Partial Load Test

ASEP IWG #7

JASIC

■ Proposal for extending the other vehicle than EV

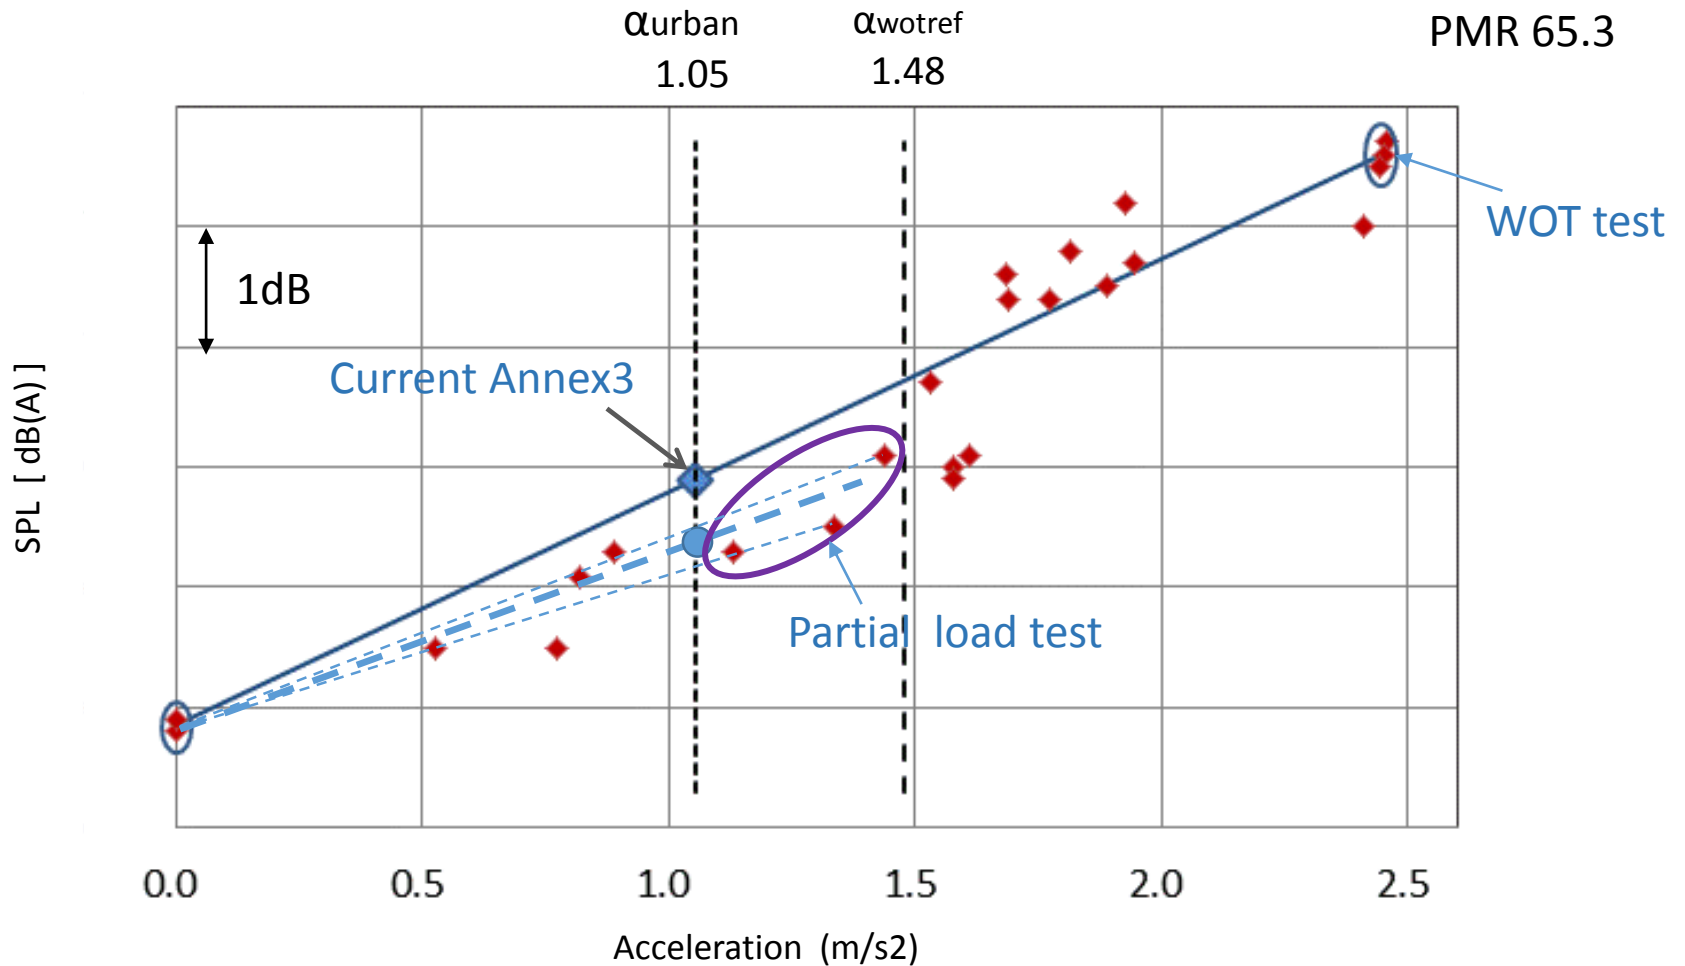
**** Applicable to vehicles except for vehicles with manual transmission, automatic transmissions, adaptive transmissions or CVTs tested with locked gear ratios.

Confirmation of Current ASEP

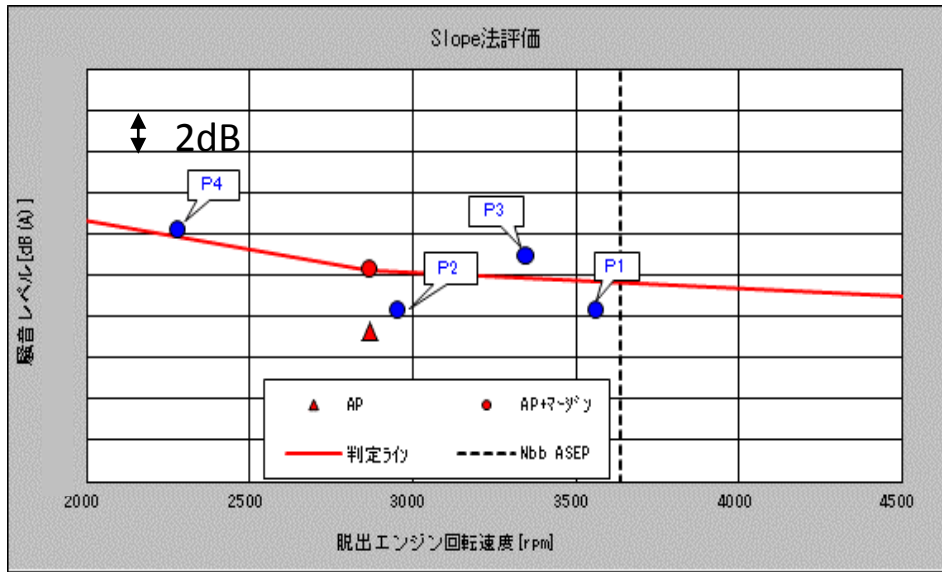
Negative slope for slope assessment.
So L_{urban} assessment should be used.
L_{urban} assessment is complied.

Question; Locked or Non-locked gear for this car?

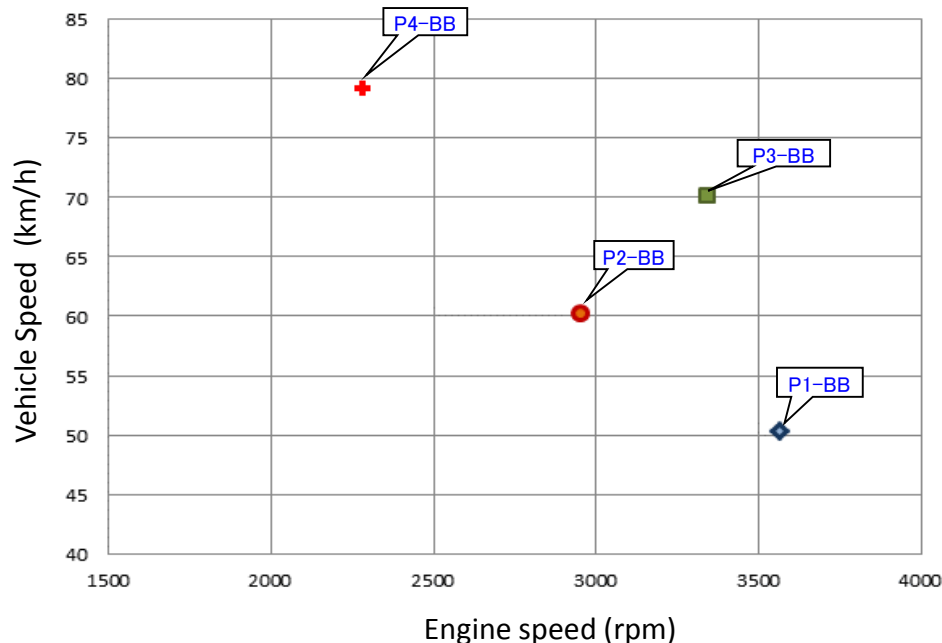
In case of non-locked conditions, if $Slope_k < 0$, the selected transmission setup is not valid.
But the other case...?

- All the cases of negative slope as well as non-locked gear case should not be valid.
- In this case L_{urban} Assessment should be used.

Confirmation of Current ASEP

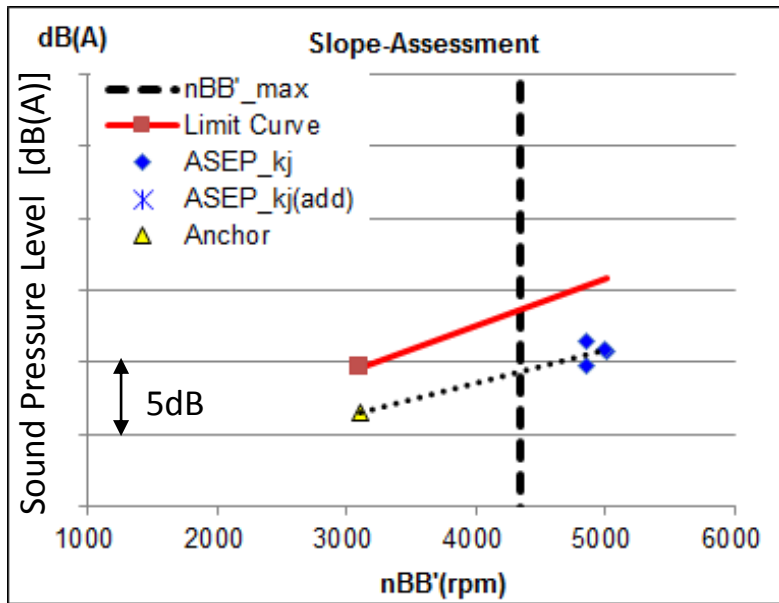
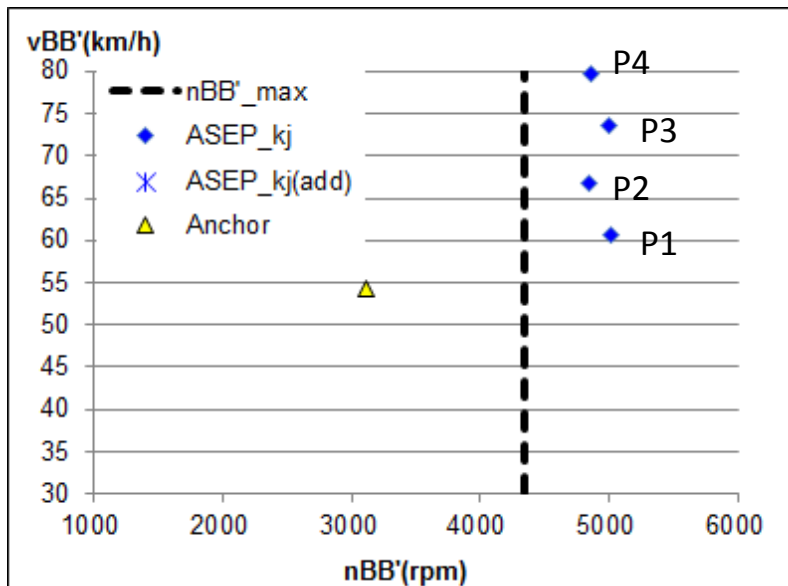
In this case, no valid set of data due to engine speed exceeds $n_{BB,ASEP}$. It is similar to typical CVT characteristics that is narrow range of engine speed for n_{BB} at P1~P4

ASEP Sound model for example car No.1

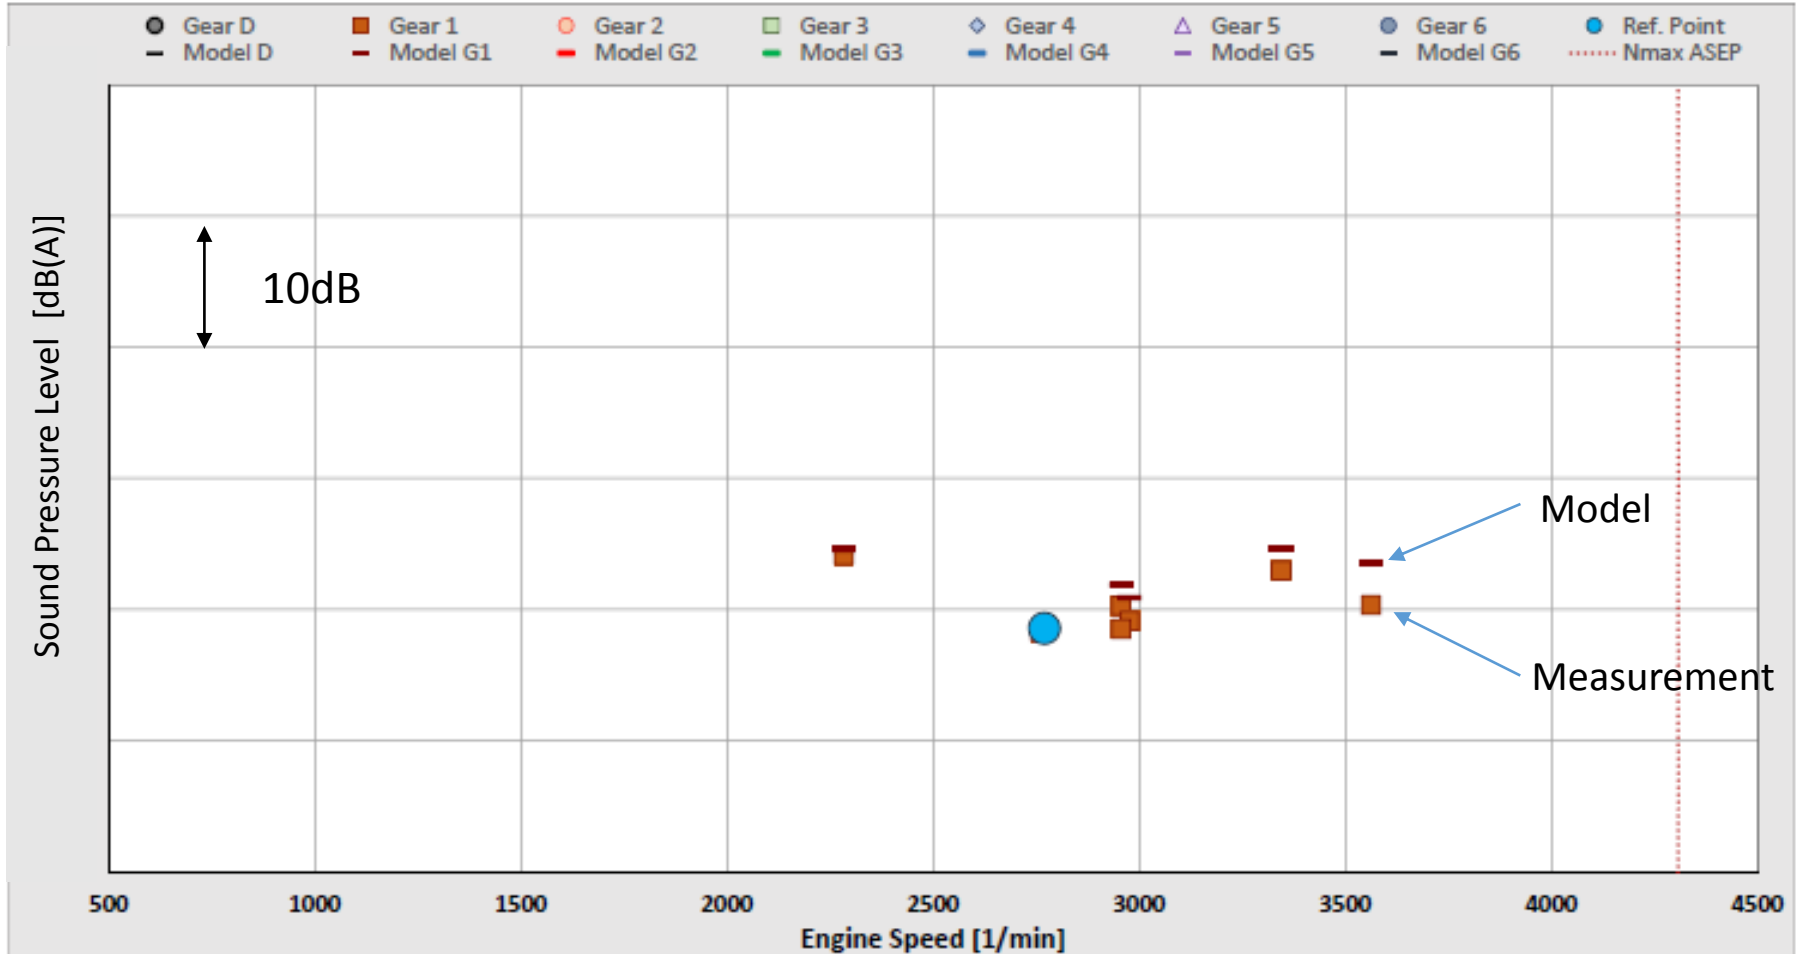
The sound model made by ASEP IWG works well.

ASEP Sound model for example car No.2

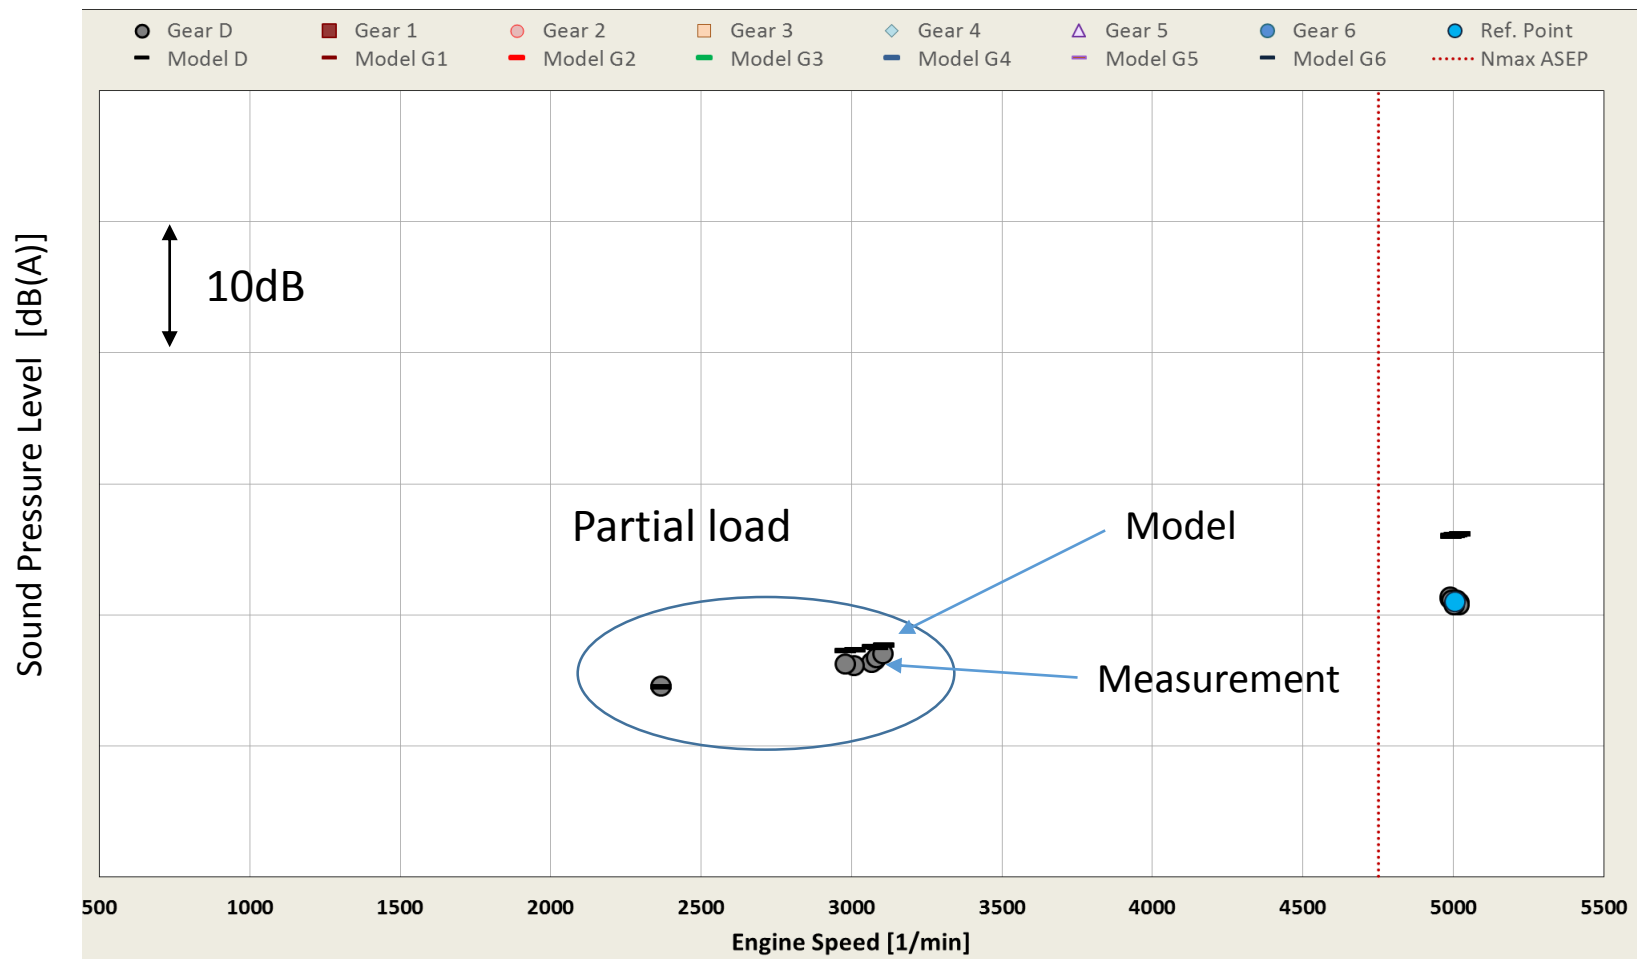
The sound model made by ASEP IWG works well.
